DEPARTMENT OF PLANNING AND DEVELOPMENT
CITY OF CHICAGO

Re: Minor Change to PD 1509
Sub-parcel 1.H

**Re: MODIFIED Request for Minor Change to Business-Residential Planned
Development No. 1509
Bronzeville Lakefront (Sub-Parcel 1.H Interim Site Plan)**

Landscape Ordinance Comparison Bronzeville Lakefront - Temporary Parking Lot

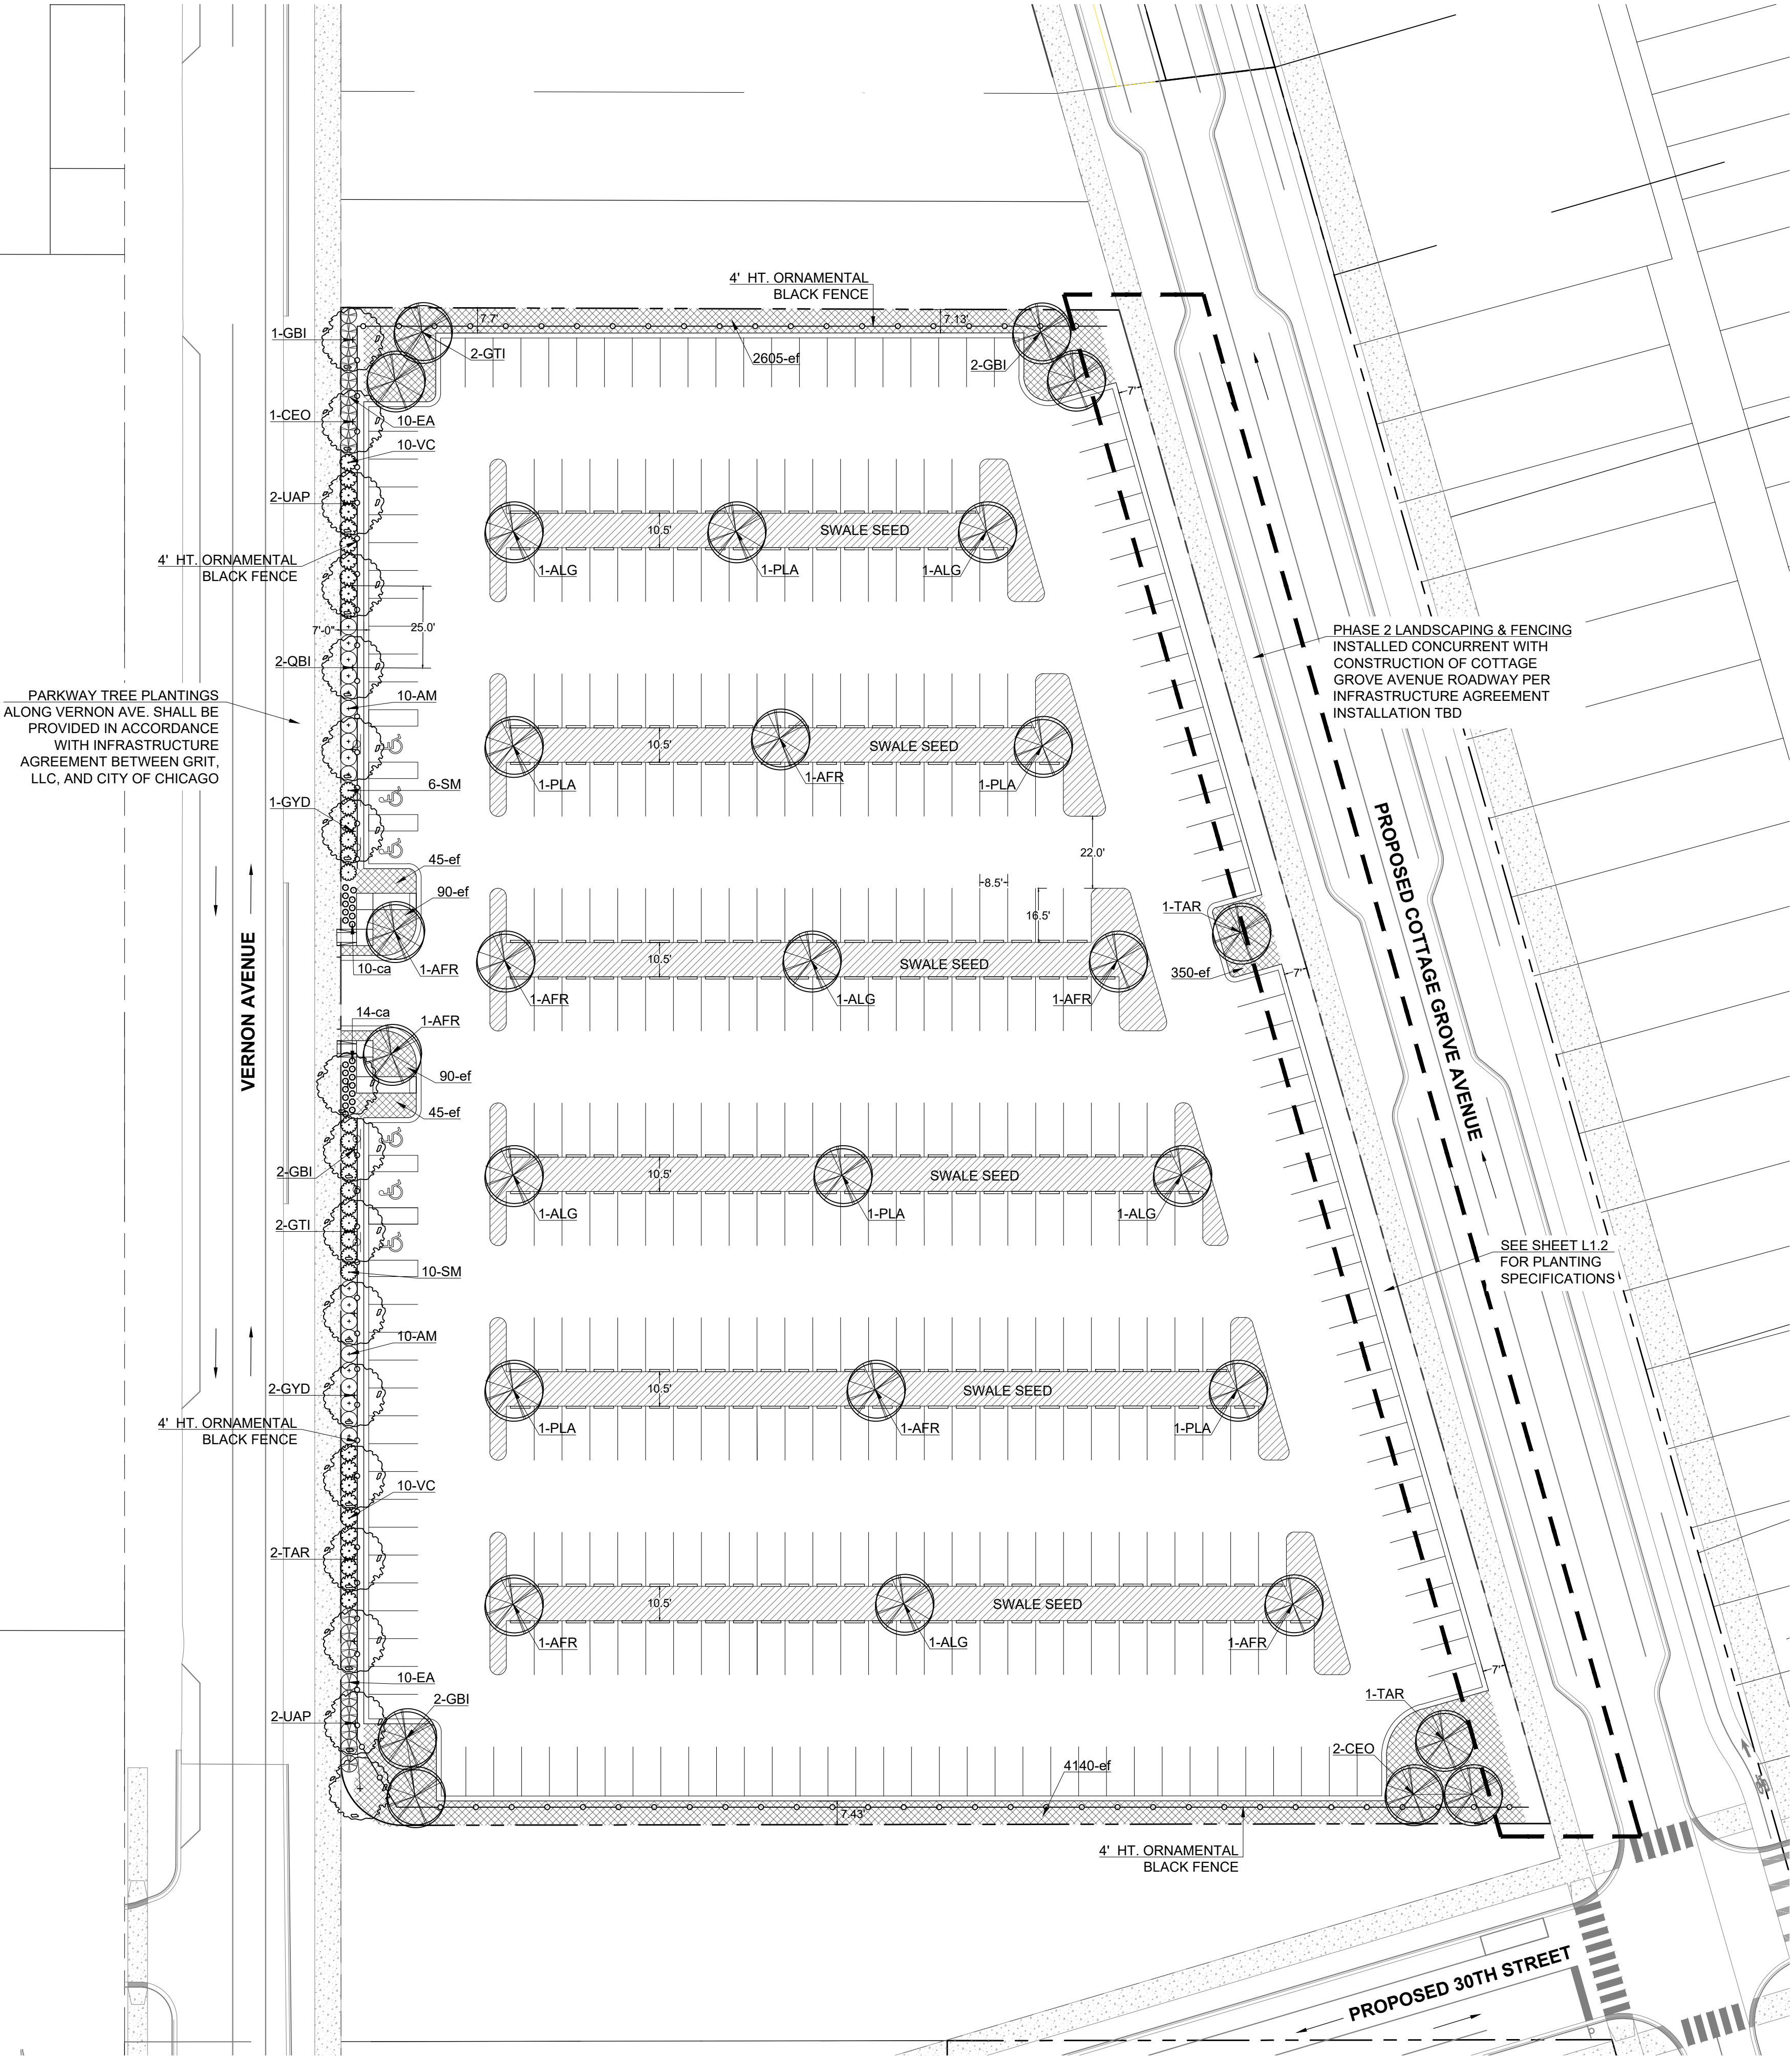
- Eliminate the hose bibb requirement for the perimeter landscape area and provide a long-term watering and maintenance contract in lieu of the hose bibs.
- Install only 30 of the 88 required interior trees on the subject site, as shown on the attached Landscape Plan Phase 1 and Landscape Plan Phase 2.
- Install the remaining 58 required interior trees throughout Subarea 3A, as shown on the attached Site A, Site B, Site C, Site D, and Site E Site Plans.
- Provide planted ground cover and native seed mix in the internal landscape islands.

Item	Ordinance Requirement	Proposed Plan
Minimum Perimeter Landscape Area Width Along ROW Frontage (See Note 1)	7'	7'
Provide Continuous Shrub Hedge (30"-48" in Height) along Public ROW Frontage	Required	Provided
Provide One Tree per 25 LF of Public ROW Frontage (See Note 1)	38 Trees Required	38 Trees Provided
Provide 4' Ornamental Fencing along Public ROW Frontage	Required	Provided
Provide Hose Bibb every 100' in Perimeter Landscape Area	Required	Not Provided (See Note 2)
10% of VUA (Vehicular Use Area) Required for Internal Planting Area	10,806 SF Required	29,565 SF Provided
Provide One Tree per 125 SF of Required Internal Planting Area	88 Trees Required	30 Trees Provided (See Note 3)
Internal Islands shall be planted with a living material	Required	Provided (See Note 4)

1. Calculation based on Cottage Grove Ave. and Vernon Ave. ROW frontage only.
2. In lieu of hose bibs a watering contract shall be provided to confirm watering is provided.
3. An additional 58 trees shall be provided within the PD Boundaries.
4. Living Ground Cover will consist of planted ground cover and native seed mix in internal depressed islands.

Regarding your request, the Department of Planning and Development has determined that allowing the proposed modifications will not create an adverse impact on the Planned Development or surrounding neighborhood, will not result in an increase in the bulk or density, and will not change the character of the development, and therefore, would constitute a minor change. The duration of the interim parking lot condition is approved for a period thirty-six months with the ability to request a 1-year extension, via a minor change. Accordingly, pursuant to the authority granted by the Chicago Zoning Ordinance and PD 1509, I hereby approve the foregoing minor change, but no other changes to this Planned Development.

PRELIMINARY LANDSCAPE PLAN
PHASE I
PLANTING REQUIREMENTS
FENCE DETAIL

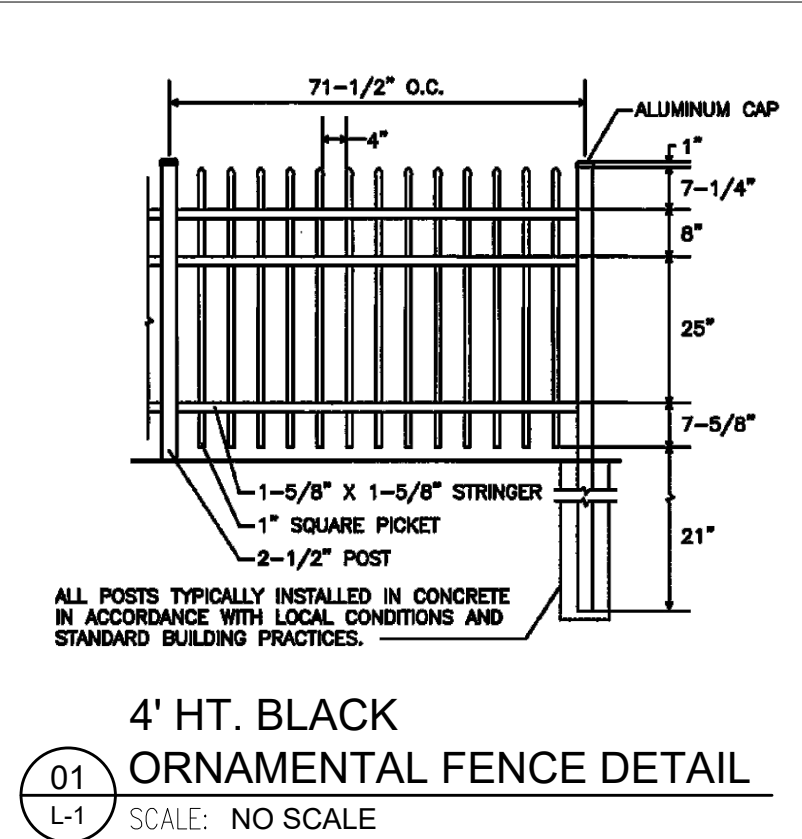
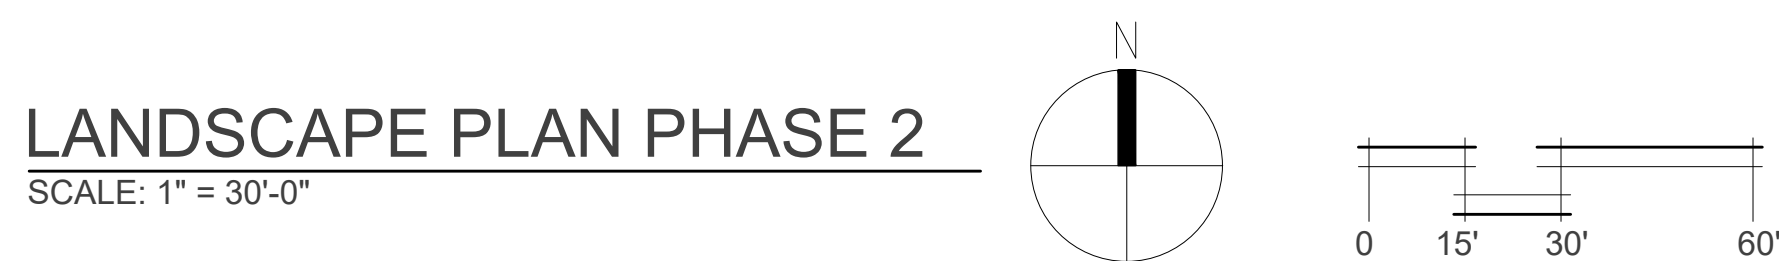
- Preliminary Landscape Plan Phase I Planting Requirements Fencing Detail, Sheet L 1.1, prepared by Kathryn Talty Landscape Architecture as Job No. 21460 and dated “per City Comments” as of January 7, 2022;
- Preliminary Landscape Plan Phase II Construction Notes Planting Details, Sheet L 1.2, prepared by Kathryn Talty Landscape Architecture as Job No. 21460 and dated “per City Comments” as of January 7, 2022; and
- Plan depicting location and planting details of 58 additional trees to be located elsewhere within the PD.

While the initial minor change plan omitted perimeter trees, perimeter trees are now provided along the length of Cottage Grove Avenue and Vernon Avenue. Thirty-eight perimeter trees are required. Thirty-eight perimeter trees are provided.

- The modifications also restore ornamental fencing to the plan, in excess of what was contemplated by the PD-approved plan. The PD-approved plan specified a 4-foot tall ornamental metal fence in the areas adjacent to Vernon Avenue and Cottage Grove Avenue. No fencing was specified along the northern or southern boundaries, or along the interior eastern boundary. The initial minor change plan sought to substitute the ornamental fencing with chain link fencing due to the construction activities that would immediately ensue on the adjacent rights of way. However, in response to DPD's comments, the enclosed modified plans depict 4-foot tall ornamental fencing on all sides of the interim parking lot.

- Interior trees have been restored to the enclosed modified plans. The initial minor change plans omitted interior trees. The interior landscaped islands are acting as swale areas and will be planted with living material consisting of planted ground cover and native seed. Because trees are not as able to withstand the swale function, the Applicant proposes to reduce the number of trees in the internal islands. Due to the temporary nature of the interim lot, the tree canopy would not have sufficient time to mature to impact the heat island effect. Instead, to offset the required number of internal trees, the Applicant would install trees elsewhere within the PD, as shown on the enclosed plans. Eighty-eight internal trees are required. Thirty internal trees would be located in the interim lot, and the remaining 58 would be located in the PD, as shown on the enclosed plans.

- To optimize construction sequencing, plantings and fencing in the landscaped buffers will be installed in two phases, as depicted on the enclosed plans. Plantings and fencing along the northern, southern, and western (Vernon Avenue) perimeters and on the interior of the interim lot will be installed in the first phase. Plantings and fencing along Cottage

Sub-Parcel 1.H Interim Site Plan - Landscape
Exhibit 18

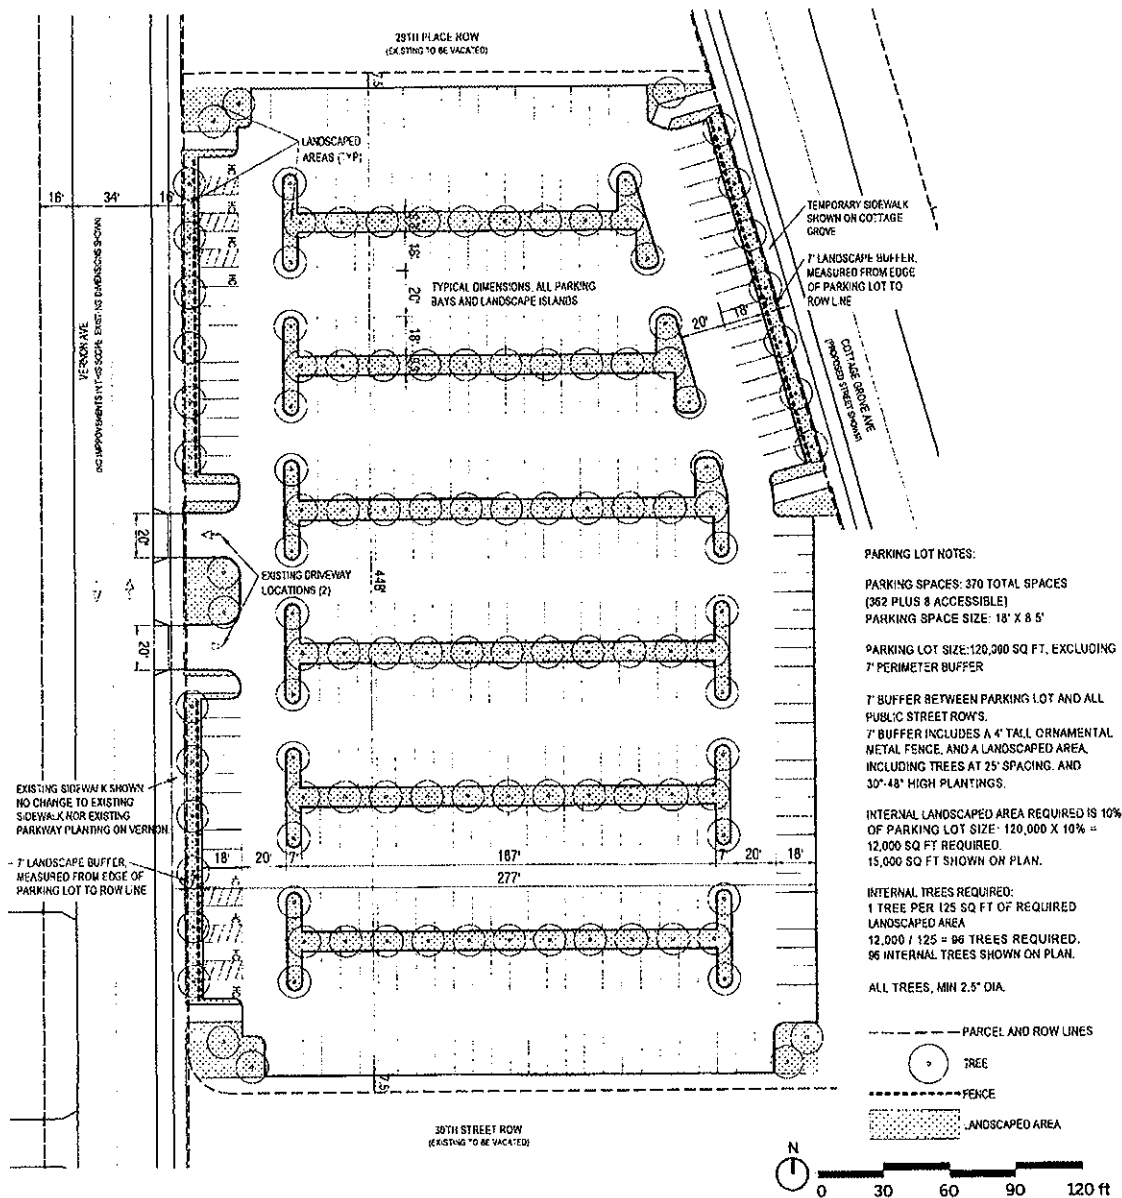
- The modifications include reconfiguring the interim parking lot so that its eastern boundary follows the line of Cottage Grove Avenue. On the PD-approved plan, the eastern boundary was adjacent to Cottage Grove only at the northeast corner of the interim lot.

- The enclosed modified plans also provide more internal landscaped area than was specified on the PD-approved plan. The PD-approved plan specified 15,000 square feet of internal landscaped area, which was 25% more than what the Landscape Ordinance requires. Based on the adjusted interim lot configuration and area, the initial minor change plans proposed 16,160 square feet of internal landscaped area, which was approximately 46% more than what the Landscape Ordinance requires. The enclosed modified plans depict 29,565 square feet of internal landscaped area, which is 173% more than required by the Landscape Ordinance.
